## REMARKS

The present invention is directed to a method and apparatus for the implementation of reduced state sequence estimation that uses precomputation (look-ahead) to increase throughput, with only a linear increase in hardware complexity with respect to the look-ahead depth. The present invention limits the increase in hardware complexity by taking advantage of past decisions (or survivor symbols). The critical path of a conventional RSSE implementation is broken up into at least two smaller critical paths using pipeline registers. Various reduced state sequence estimation implementations are disclosed that employ one-step or multiple-step look-ahead techniques to process a signal received from a dispersive channel having a channel memory.

FIG. 5

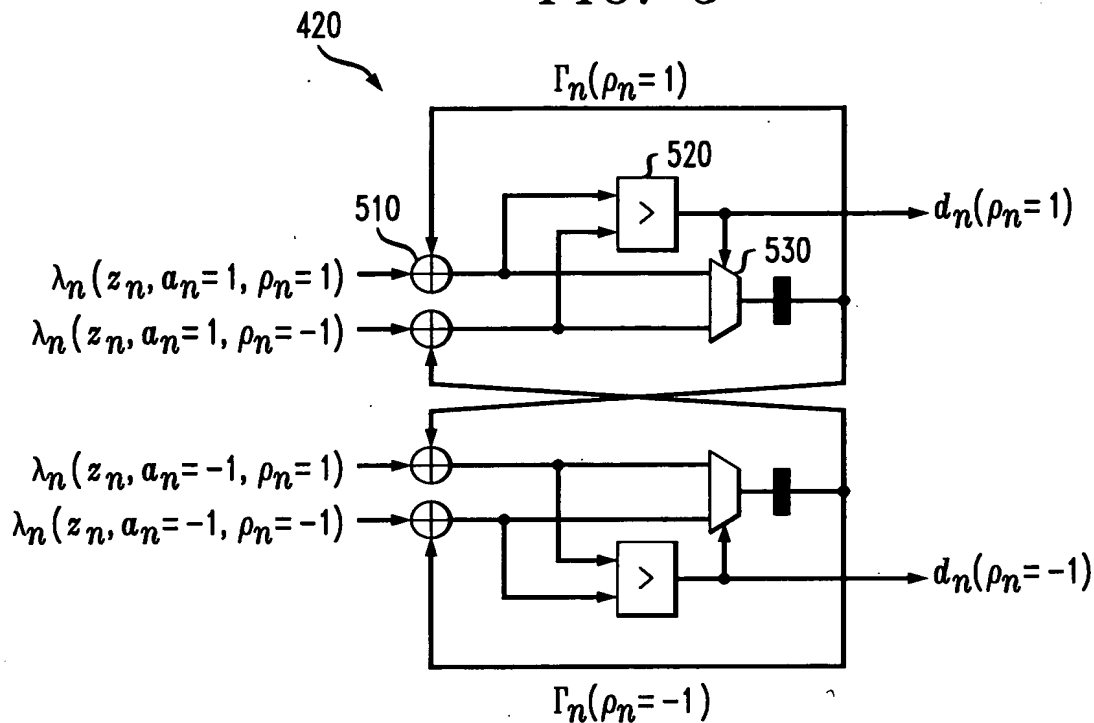
The drawings were objected to as failing to comply with 37 CFR 1.84(p)(5) because they include reference signs not mentioned in the description and because of handwriting in FIG. 14.

The drawings have been amended to delete the reference signs that were  
 15 not mentioned in the description. The formal drawings are also resubmitted herewith with a FIG. 14 that does not contain handwritten text. Applicants respectfully request that the objections to the drawings be withdrawn.
